E-mail from Victor Scoggin, Dated November 8, 2004

Letter from Morisset, Schlosser, Jozwiak & McGaw,
Dated November 11, 2004

Re: Hoopa Valley Tribe's Comments Concerning Sacramento River Settlement
 Contractors Draft Environmental Impact Statement (September 2004)

Figure 1. Escapement (number of adult fish) of spring-run Chinook salmon to the mainstem Sacramento River upstream of Red Bluff Diversion Dam. Data from CDFG.

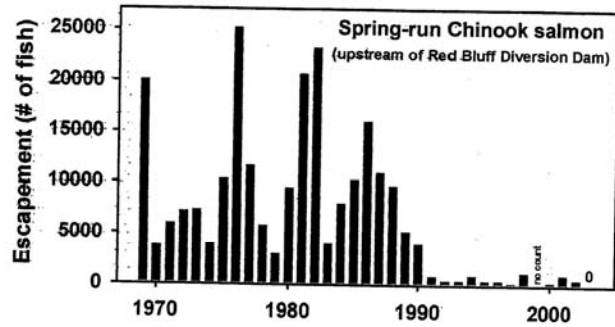
Until fifteen to twenty years ago, the majority of the run (average: >10,000 fish/year) spawned in the upper mainstem Sacramento River above RBDD (Figure 1, data from California Department of Fish and Game [CDFG]). In recent years (~1987-2003), progressively fewer fish have been able to return to the upper mainstem river, the combined result of Sacramento River water management operations that cause intolerable water temperature conditions and migration blockage and delays at RBDD (see below). As of 2003, when no spring-run Chinook salmon were reported to have returned, the Sacramento River population may have been extirpated. Presently, independent natural populations of spring-run Chinook salmon are restricted to just three Sacramento River tributaries: Mill, Deer and Butte Creeks. Given the current restricted geographic distribution and only two remaining independent natural populations (one in Mill and Deer Creeks and the other in Butte Creek), the species is "perilously close to extirpation" in the Sacramento basin (McElhany et al., 2000; Lindley et al., 2004; copies enclosed).
